Como & Chatsworth

Additional analysis based on draft plan input

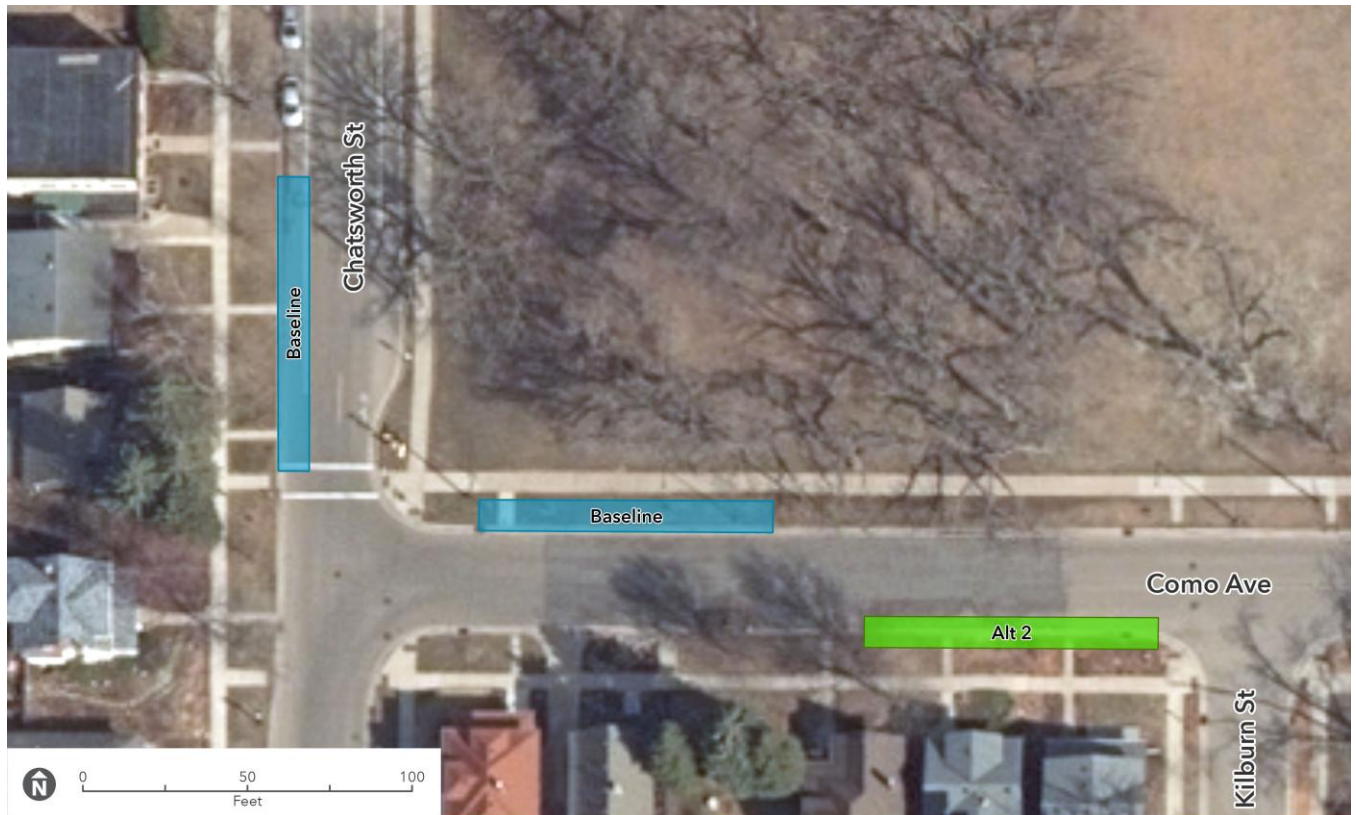
Public feedback received on the Draft Corridor Plan cited concerns about Como & Chatsworth Station placement, noting operational concerns related to conflict between buses and personal vehicles, bus turning challenges from the proposed station location at the intersection of Como Avenue and Chatsworth Street, impacts to neighborhood character, low ridership, on-street parking, and suggested removal of the station.

Two alternatives to move or remove the Como & Chatsworth Station were evaluated:

- Baseline Alternative: Como & Chatsworth Station

- Alternative 1: Remove Como & Chatsworth Station
- Alternative 2: Move the eastbound platform to Como Avenue & Kilburn Street

Following review, Metro Transit project staff recommend moving the eastbound platform to be nearside Kilburn Street on Como Avenue. Making this change improves operational concerns about buses turning between Como Avenue and Chatsworth by reducing the chances of conflict between an eastbound bus stopped at the station platform and a westbound bus trying to turn right to travel northbound on Chatsworth Street. Removing the Como & Chatsworth Station would have led to station spacing greater than 3/4 of a mile between Como & Lexington and Como & Nagasaki stations and limited access to the H Line, especially for people living south of the freight rail line, as Chatsworth Street is one of the only north/south through streets in this area.
